PACIFIC NORTHWEST NATIONAL LABORATORY
TECHNICAL LETTER REPORT

**EVALUATION OF ALTERNATIVE TO 10 CFR 50.55A(G)(6)(II)(F)(4) FOR LIMITATIONS TO
VOLUMETRIC EXAMINATIONS OF DISSIMILAR METAL WELDS**

**FLORIDA POWER & LIGHT
ST LUCIE NUCLEAR POWER PLANT Unit 1
DOCKET NUMBER: 50-335**

Figure 4. Licensee Ray Trace Volumetric Coverage and Largest Undetected Flaw for Weld RC-121-6-504 due to Spray Nozzle Limitation at Positions B and H

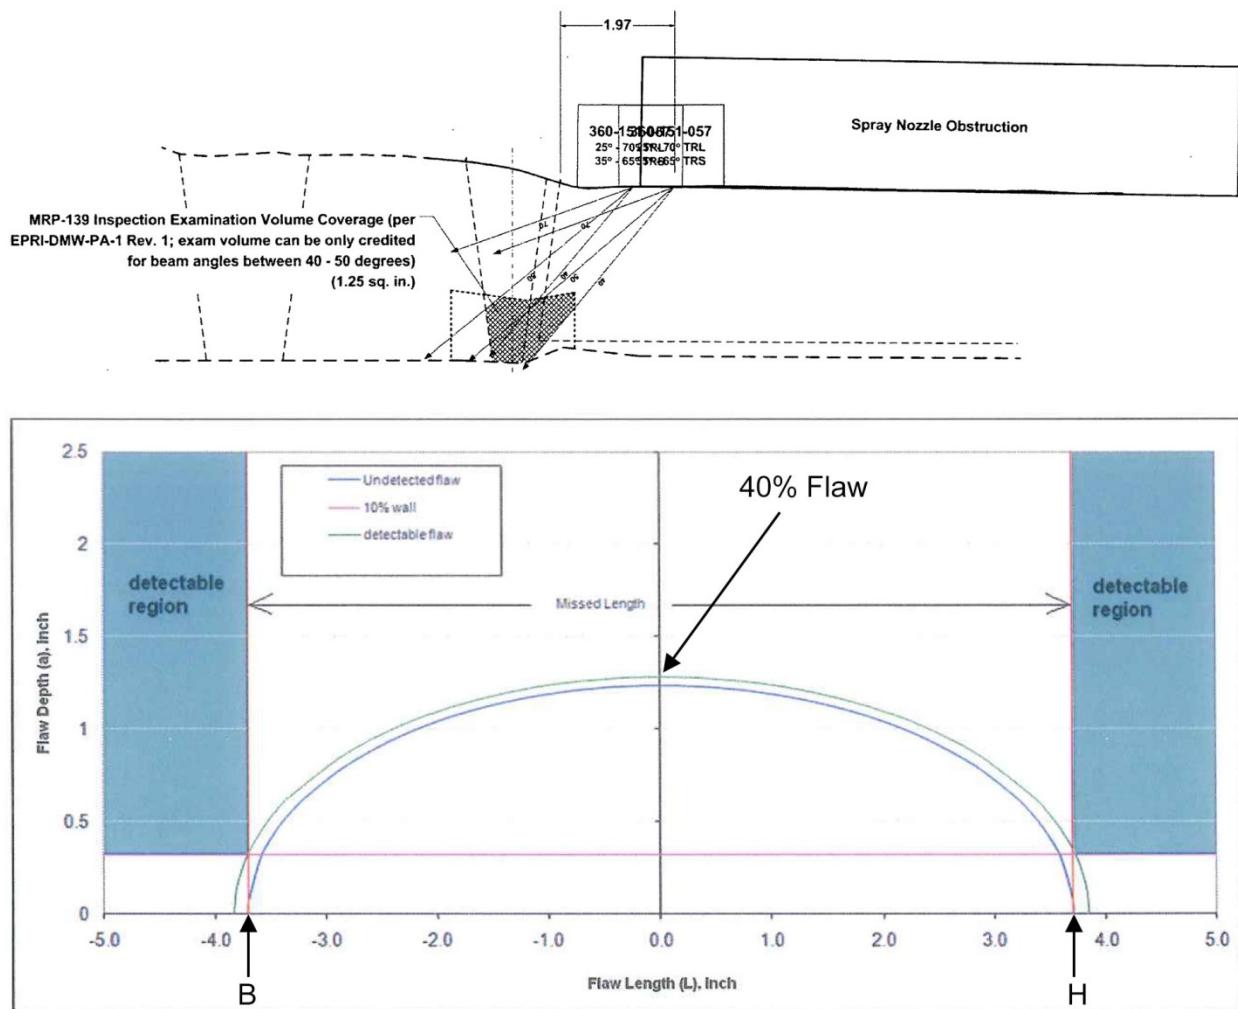
The licensee also submitted volumetric examination sketches showing theoretical beam plots between angles of 40 to 50 degrees (EPRI-DMW-PA-1 Rev. 1) for axial scan coverage obtained across all the access limitations highlighted in Figures 2 and 3; e.g., RTD Nozzle limitation positions A, B, C. The licensee's sketches indicate that the credited coverage varies as a function of the axial scanning limitation. The licensee's theoretical coverage for the Spray Nozzle obstruction at positions B and H are shown in Figure 4. At the B and H positions the licensee postulated that a flaw developing in the susceptible material region could grow to a maximum through-wall extent of 40%, 32.5 mm (1.2 in.) before detection (via flaw corner or tip specular or diffracted responses) in the region containing the Spray Nozzle. Without these limitations, axial scans could be initiated at a sufficient distance away from the weld on the carbon steel primary piping to ensure 100% volumetric coverage of the susceptible material, as full volumetric scans were completed for the remaining circumferential sections of the weld. In addition, the licensee estimated volumetric coverage for axial scans at approximately 92.1% of

the required circumference of the weld (MRP-139 Volume Coverage), which includes the full inner one-third of the susceptible weld material, as examined from the ID-clad carbon steel piping. The licensee did not take credit for the examination coverage on the CASS safe end material because the ASME Code, Section XI, has no qualification procedures for the ultrasonic examination of the CASS material.

positions on Weld RC-121-6-504, left to right, as simulated by CIVA. The models were generated using -6 dB (top) and -12 dB (bottom) filters applied to the sound beam. Although the licensee has not taken credit for angles below 40 degrees, PNNL simulated the beam coverage at lower angles demonstrating that ID coverage may be improved using lower refracted angles. PNNL found that as modeled, the 40 degree beam simulation (-12 dB filter) correlates well with the lower angle volumetric coverage provided by the licensee's description of beams from 40 to 50 degrees (as illustrated in Figure 4).

Figure 5. PNNL Modeled -6 dB (Top) and -12 dB (Bottom) Beams for 40 and 50 Degrees Respectively Located at the B and H Positions (Weld RC-121-6-504)

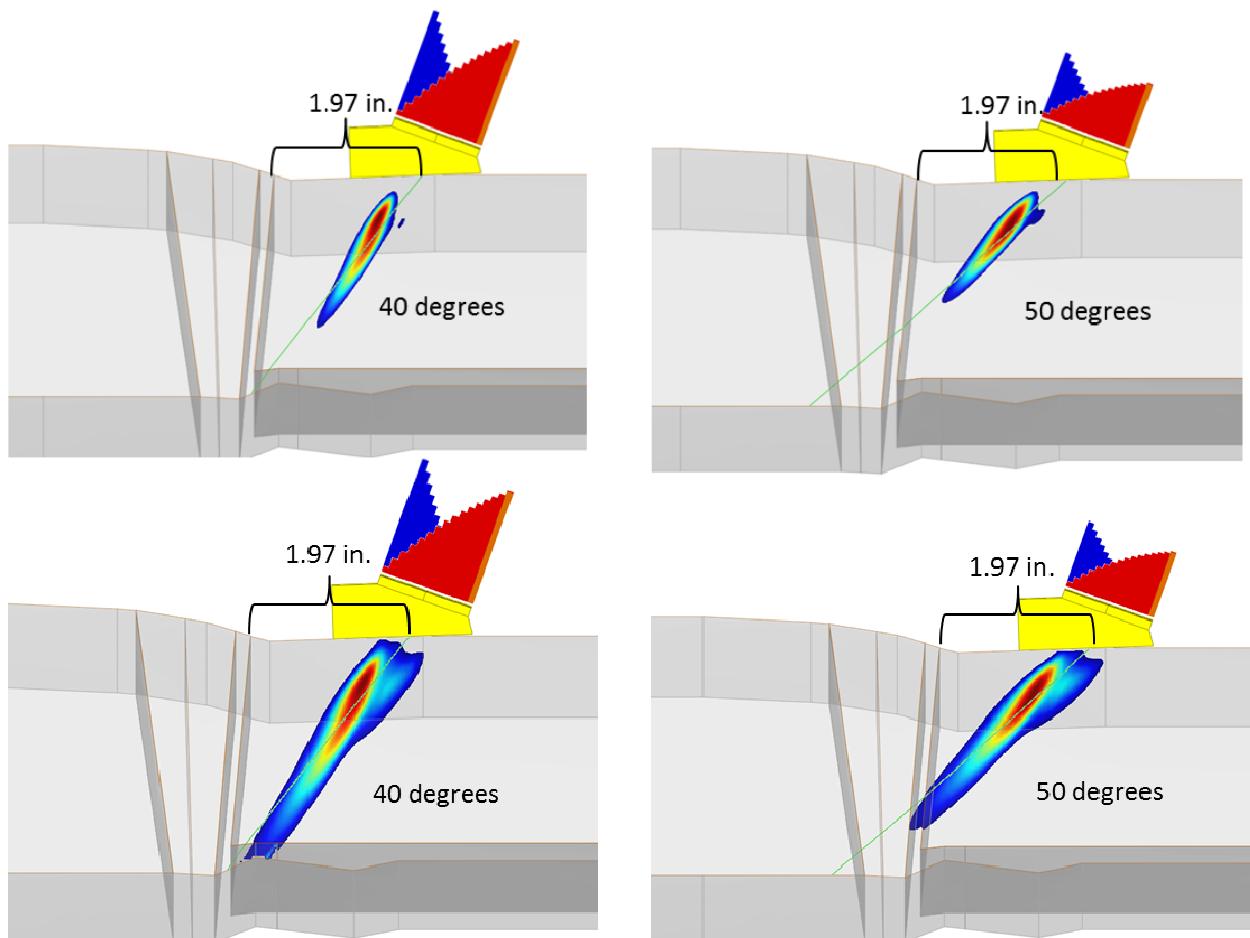
PNNL modeled theoretical ultrasonic beam intensities for the applied phased array examination using the licensee provided delay laws applied on this weld. Modeling included 5 degree increments from 25 to 70 degrees with a half path focus of 76.2 mm (3.0 in.). These focal law values, actual probe physical matrix parameters, and the idealized drawing submitted by the licensee were used as inputs to this model. Longitudinal sound field simulations were completed for all specified access limitations caused by the RTD and Spray Nozzle obstructions. Figure 5 shows examples of UT beams for 40 and 50 degrees at the B and H

The licensee's phased array probe was operated with focal laws defined to produce steered beams from 25 to 70 degrees, at one-degree increments, each focused at approximately 76.2 mm (3.0 in.) of metal path after exiting the probe. This focal length is short of the ID surface for all steered beams used in the inspection—especially beam angles between 40 and 50 degrees. For reference, the theoretical metal path as calculated along a 40 degree refracted angle originating from the exit point of the wedge (component OD surface) and traveling to the

ID of the component, is nominally 96.2 mm (3.79 in.) where the actual thickness of the carbon piping component is 73.7 mm (2.9 in.).

Therefore, the licensee's model predicts that all sound beams in the accredited angle range (40-50 degrees) to have less than -6 dB beam intensities near the ID of the weld. The -6 dB value represents a point where field intensity is diminished by 50% of the initial maximum; every -6 dB is an additional 50% reduction. However, for a 40-degree beam, the PNNL model predicts -12 dB ID coverage of the weld for this particular inspection angle; this equates to a factor of 4 times lower initial sound energy at this angle. PNNL notes that angles greater than 40 degrees would also have less energy at the ID of the weld. The PNNL model represents a "best-case" scenario; that is, no material attenuation or backscattering from coarse grains in the weld is included. These factors as well as the potential for coupling inefficiencies will typically lower the amplitudes of signal responses from real flaws under field weld conditions, resulting in decreased signal-to-noise ratio (SNR), and making flaw detection significantly more challenging outside the -6 dB region.

Figure 8. Licensee Ray Trace Volumetric Coverage for Weld RC-124-7-504 due to Spray Nozzle Limitation at Position C

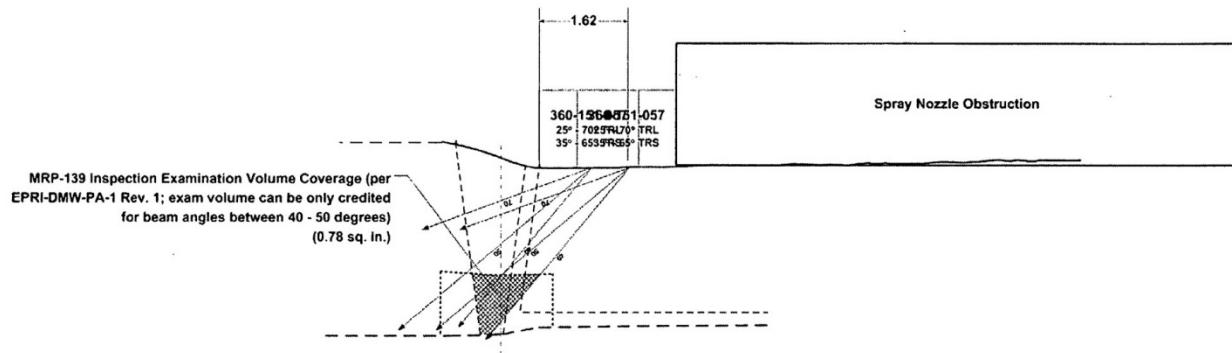
The licensee also submitted volumetric examination sketches, showing theoretical beam plots between angles of 40 to 50 degrees (EPRI-DMW-PA-1 Rev. 1) for axial scan coverage obtained across all access limitations highlighted in Figure 7; e.g., Spray Nozzle limitation positions A, B, C, D, and E. The licensee's sketches indicate that the credited coverage varies as a function of the axial scanning limitation. The licensee's theoretical coverage for the Spray Nozzle obstruction at position C is shown in Figure 8. Without these limitations, axial scans can be initiated at a sufficient distance away from the weld on the carbon steel primary piping to ensure 100% volumetric coverage of the susceptible material, as full volumetric scans were completed for the remaining circumferential sections of the weld. Due to the scanning limitations described, the licensee estimated volumetric coverage for axial scans at approximately 97.7% of the required circumference of the weld (MRP-139 Volume Coverage), which includes the full inner one-third of the susceptible weld material, as examined from the ID-clad carbon steel piping. The licensee did not take credit for coverage on the CASS safe end material because

the ASME Code, Section XI, has no qualification procedures for the ultrasonic examination of the CASS material..

Figure 9. PNNL Modeled –6 dB (Top) and –12 dB (Bottom) Beams for 40 and 50 Degrees Respectively Located at the C Position (Weld RC-124-7-504)

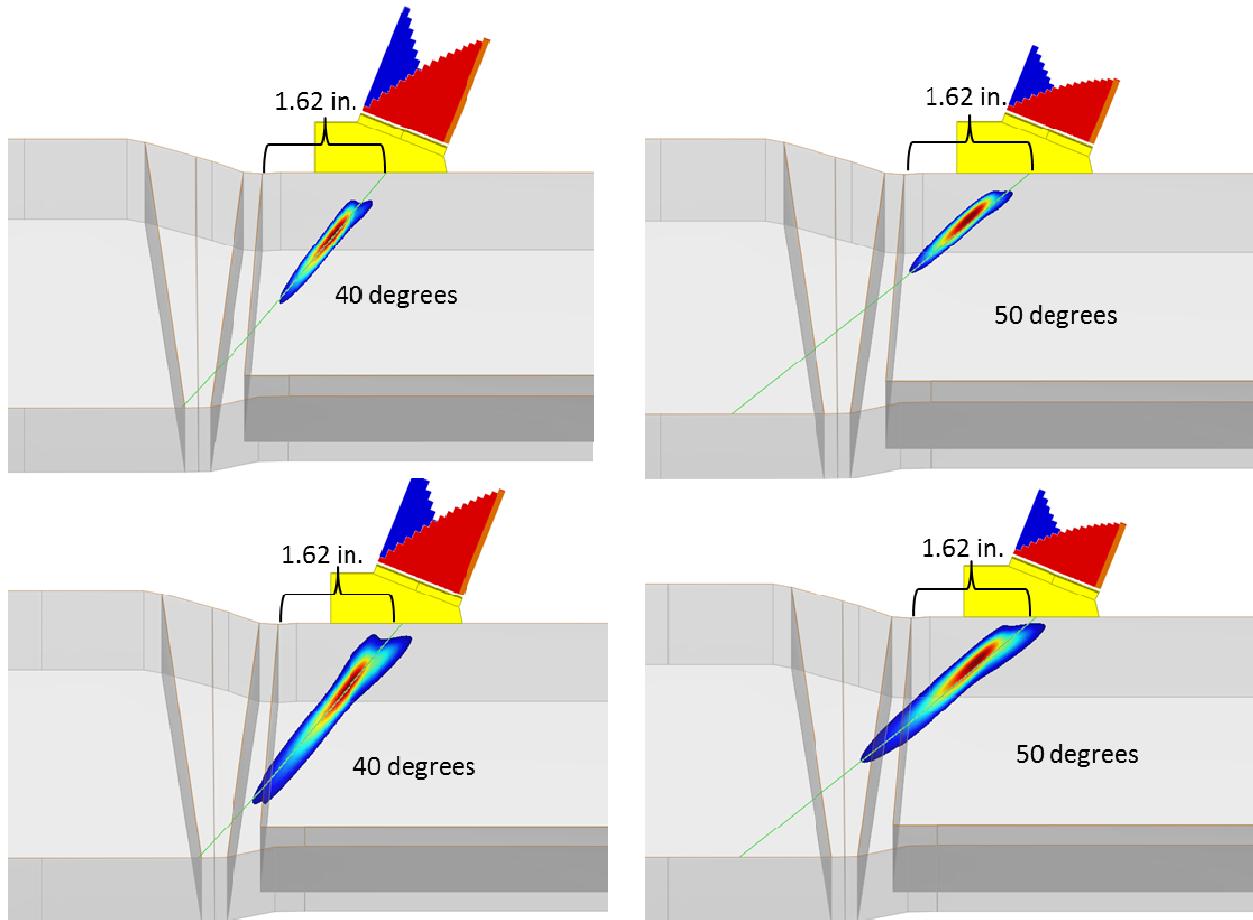
PNNL modeled theoretical ultrasonic beam intensities for the applied phased array examination using the licensee provided delay laws applied on this weld. The model included 5 degree increments from 25 to 70 degrees with a half path focus of 76.2 mm (3.0 in.). Longitudinal sound field simulations were completed for all specified access limitations for the Spray Nozzle obstruction. Figure 9 provides examples of UT beams for 40 and 50 degrees at the B and H positions on Weld RC-124-7-504, left to right, as simulated by CIVA. PNNL generated the models using -6 dB (top) and -12 dB (bottom) filters applied to the sound beam. Again, although the licensee has not taken credit for angles below 40 degrees, PNNL simulated beam coverage at lower angles demonstrating that ID coverage may be improved using lower refracted angles. As modeled, PNNL's 40 degree beam simulation (-12 dB filter) mostly agrees with the lower angle volumetric coverage provided by the licensee's description of beams from 40 to 50 degrees (as illustrated in Figure 8).

Figure 13. Defect Response at 40 Degrees with Probe Located at the B and H Position; 40% Through Wall Flaw

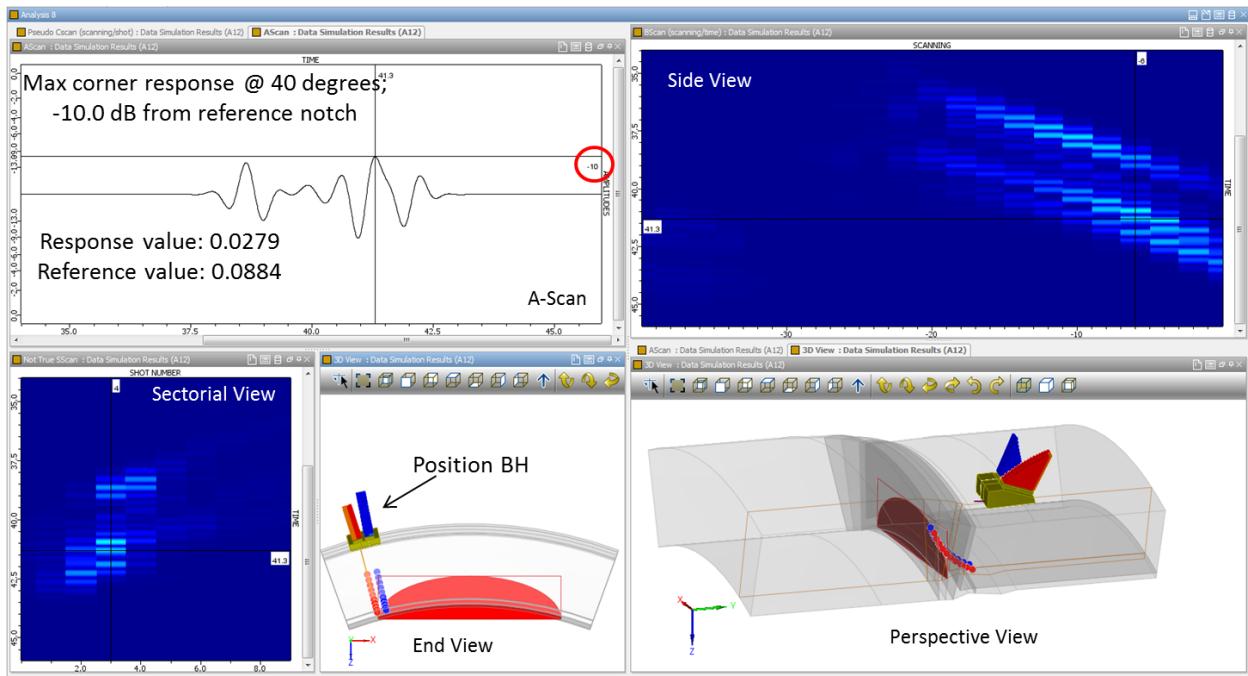
Figure 13 shows results of the backscattered response simulation with a 40 degree scan angle. The lower right two images show views of the probe on the component at the B and H position, with maximum distance to weld centerline as could be expected due to the Spray nozzle obstruction. The lower left image is an unprocessed non-volume corrected sectorial display showing all angles simulated versus time at a particular scan position. This view shows simulated flaw responses (if existent) for angles 25-70 degrees, at 5 degree increments (25 degrees on the left and 70 degrees on the right). The black cursors in this image are centered on the 'shot' number corresponding to 40 degrees. The upper right image shows a side view (scanning vs. time) that correlates with the selected refracted angle. The upper left quadrant shows the time-amplitude A-Scan view with the black cursor located at the maximum response detected from the 40% semi-elliptical planar flaw when detected with the probe located at the B-H position. The A-scan image with amplitude measured in decibels indicates that the specular (ID corner trapped) signal from the semi-elliptical flaw at this 40 degree angle is -10 dB below (circled in red) the calibrated 10% notch response. For reference, the normalized system response value is 0.0279 as compared to the calibration notch response value of 0.0884. As previously stated, a measure of comparison for a -12 dB reduction is 1/4 or 25% of the maximum response. When the simulated scan progressed away from the start position (toward the weld region), the postulated flaw disappeared from view in the simulation. Thus, it is imperative that the scan begin at the simulated starting point (as far back from weld centerline as possible) for the most reliable detection. The A-scan also displays the upper flaw reflection, or simulated tip signal, shown earlier in time than the ID-corner response.

Figure 14 Defect Response at 40 Degrees with Probe Located at the B and H Position; 50% Through Wall Flaw

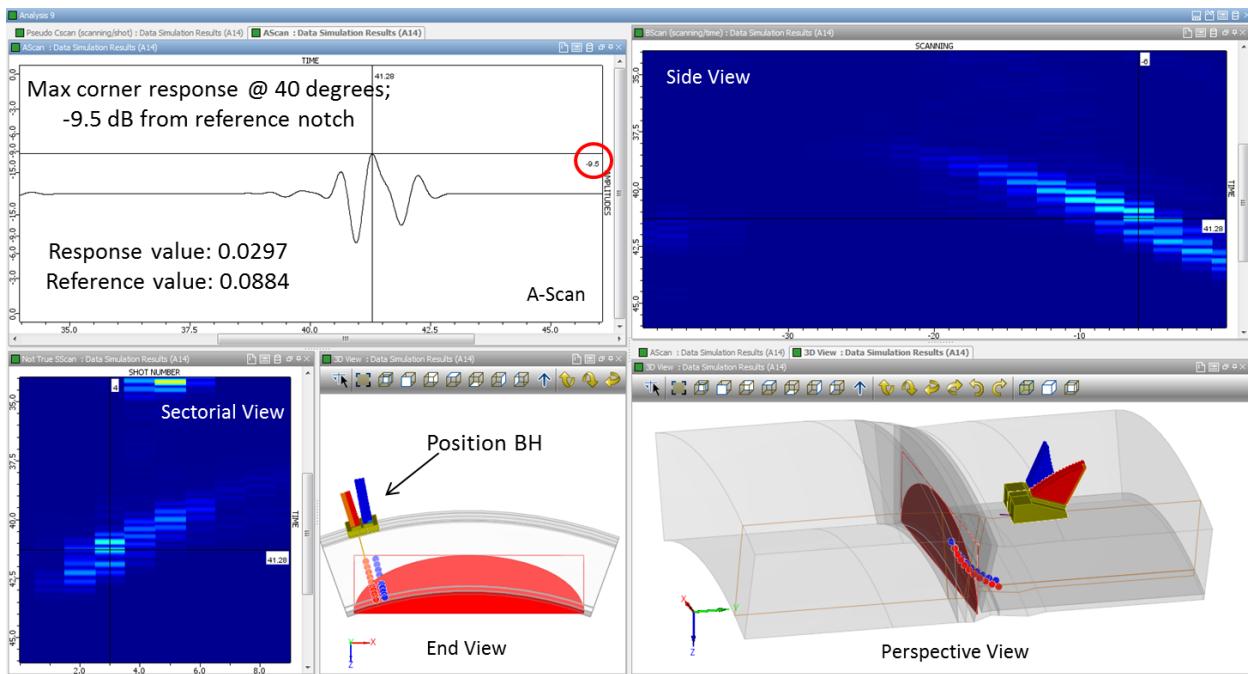
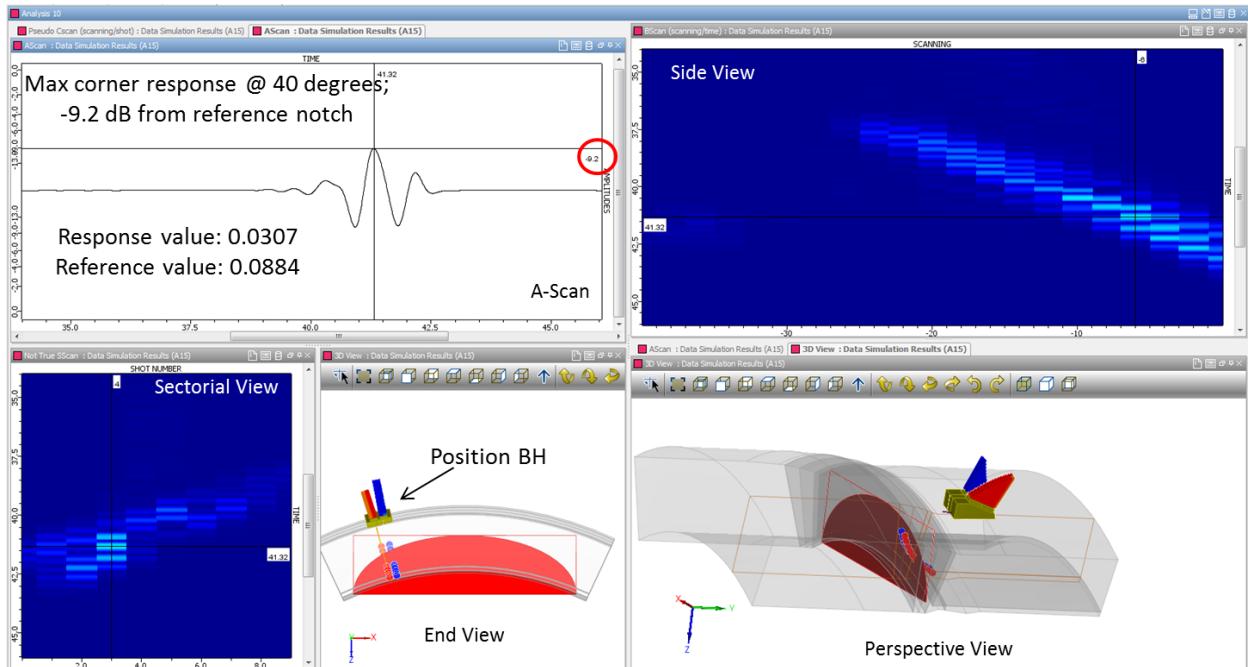
Based on discussions with NRC, PNNL conducted second and third evaluations at the B-H position using an AR 6:1 semi-elliptical planar flaw that has grown to a maximum through wall extent of 50%, or 40.6 mm (1.6 in.) and 60%, or 48.8 mm (1.9 in.), respectively. These simulations were performed to determine if increasing the flaw size raises the likelihood of theoretical detection as compared to the 10% reference notch. Similar to the presentation of the data shown in Figure 13, Figures 14 and 15 illustrate the computer-generated detection of the corner response from 50% and 60% through wall flaws, respectively, as examined from the B-H position with maximum distance from weld centerline. The 50% and 60% flaws indicate an amplitude reduction from the flaw corner of -9.5 dB (response value 0.0297) and -9.2 dB (response value 0.0307) from the reference notch response (circled in red in the figures).

Thus, over the through wall extent range from 40% to 60%, the simulations show that only slight amplitude increases in ID corner-trap responses at 40 degrees occur as the through-wall extent of the flaw increases. Table 1 highlights the trend, albeit small, observed. This is expected and is likely the result of an increase in flaw surface area being presented to the focused inspection beam. One would also expect this trend to reach a peak, once the beam-to-flaw impact area has been exceeded, i.e., the flaw grows beyond the radial dimension of the sound beam.

Figure 16 Top of Flaw Defect Response at 50 Degrees with Probe Located at the B and H Position; 50% Through Wall Flaw

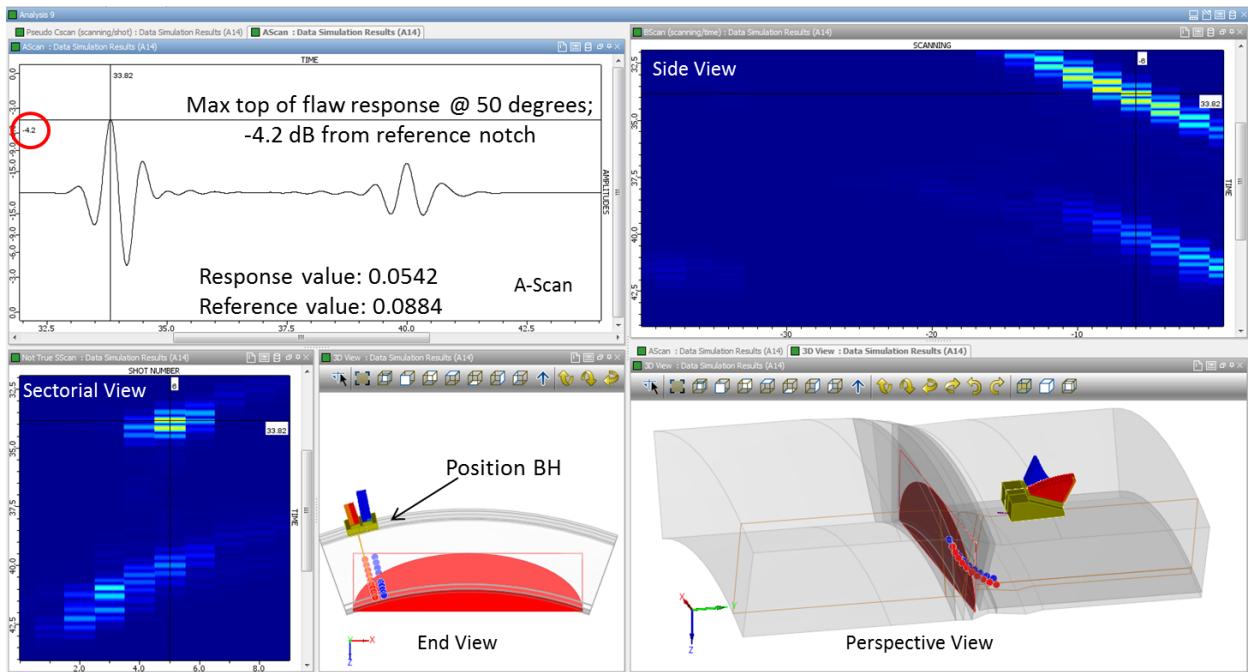
A further analysis of top of flaw responses was also conducted using the semi-elliptical 50% through wall simulation as compared against the 10% reference notch. This revealed that the top response, or simulated tip signal, of the 50% flaw located at the B-H position exhibited only a -4.2 dB (response value 0.0542) amplitude reduction from the reference notch, when using a refracted angle of 50 degrees. The 50-degree angle was chosen because it represents the best impingement for top-of-flaw responses at the B-H position, and is the highest angle in the range of those having been qualified by the licensee. For purposes of comparison, the maximum response detected from the top of the 40% through wall flaw at the B-H position was -11.5 dB below the reference notch top-of-flaw response. Therefore, the less than -6 dB change between the 10% reference and the 50% through-wall planar flaw would indicate a favorable detection scenario.
